The attached letter provides the comments of the Citizens Committee to Complete the Refuge regarding the Revised 401 Water Quality Permit Application of the San Francisco Creek Joint Powers Authority.

**RE: 401 Water Quality Certification Application for the San Francisquito Creek Joint Powers Authority's Bay to 101 Flood Reduction Project.**

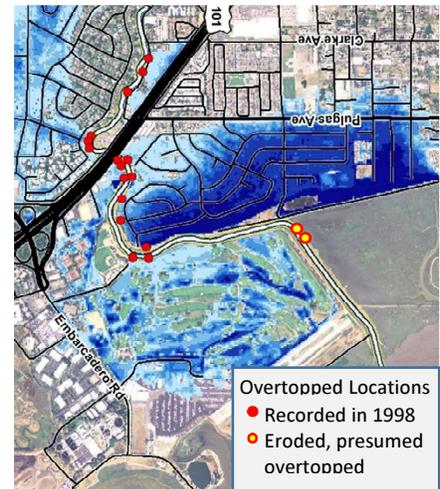
Levee Heights: The Project's construction proposals for the Middle Reach of the creek include specifications for at-build height that allows for post-construction compaction. Along the EPA side the levee would be 6" taller than final anticipated height. Along the left side, the levee would be 12" taller at-build. The Project explains<sup>2</sup> that this is due to differences in the compressible characteristics of underlying soils. Has that assumption been adequately analyzed? What is the variability in range of compaction and/or time of compaction that may be expected? But more important, why is there a proposal to provide equal<sup>3</sup> protection along the Middle Reach when the flood risk is clearly far, far greater to East Palo Alto and for which any degree of vulnerability of the golf course could reduce risk along the opposite bank? We are not well

informed on homeowners flood insurance but wonder if a more vulnerable golf course levee would be supportive to reduced rates for EPA residents.
